# **ADDITIONAL DRAWINGS**

## Proposed New House and Garage 12 Park Road Penarth CF64 3BD 2016/00176/FUL

Design and Access Addendum

Submitted Scheme from NE

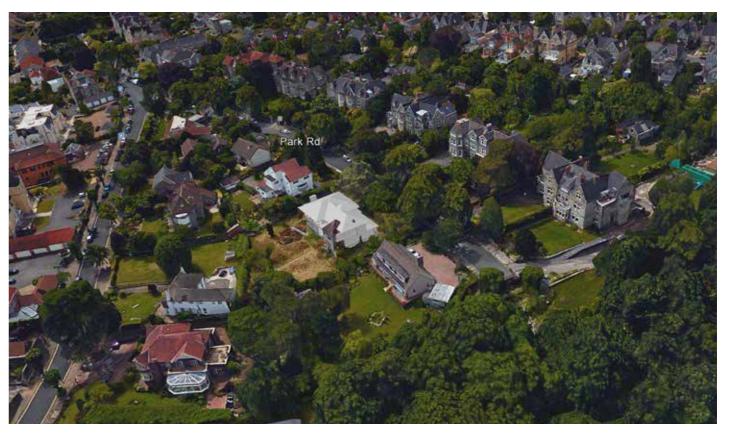
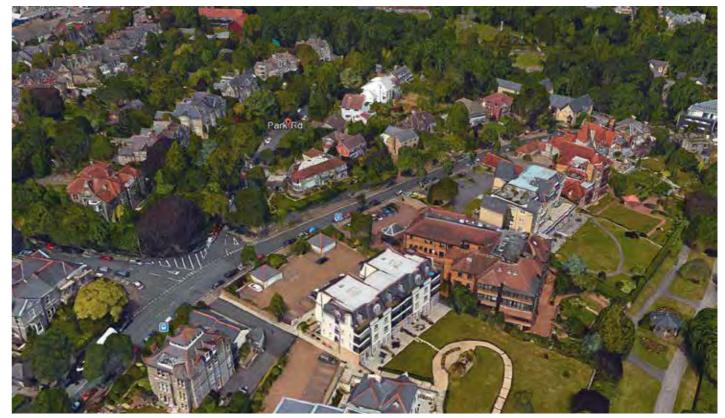
Approved Scheme from NE

Approved Scheme from SW

Current scheme from SW
